Title - Sujet Steveston Paramount Wharf 403 Recon Reconstruction du quai 403 de Steveston Paramount	
Solicitation No. - N° de l'invitation F1571-210984/A	Amendment No. - N° modif. 009
Client Reference No. - N° de référence du client F1571-210984	Date 2022-01-27
GETS Reference No. - N° de référence de SEAG PW-\$PWY-028-9095	
File No. - N° de dossier PWY-1-44142 (028)	CCC No./N° CCC - FMS No./N° VME
Solicitation Closes - L'invitation prend fin at - à 02:00 PM Pacific Standard Time PST on - le 2022-02-01 Heure Normale du Pacifique HNP	
F.O.B. - F.A.B. Plant-Usine: <input type="checkbox"/> Destination: <input checked="" type="checkbox"/> Other-Autre: <input type="checkbox"/>	
Address Enquiries to: - Adresser toutes questions à: Lam (PWY), Tian	Buyer Id - Id de l'acheteur pwy028
Telephone No. - N° de téléphone (604) 363-7968 ()	FAX No. - N° de FAX () -
Destination - of Goods, Services, and Construction: Destination - des biens, services et construction: DFO – Steveston Paramount Wharf 403 – Richmond, BC

The Solicitation Amendment 009 is raised to issue Addendum 006.

See Addendum 006 herein.

Q1. Extent of Timber Decking

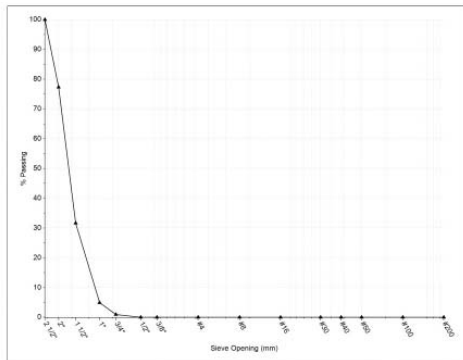
Amendment 3, Addendum 2 and Amendment 5, Addendum 3 indicate the timber decking within the footprint of the building will be removed by others. Does this include stringers as well?

A1: No, it does not.
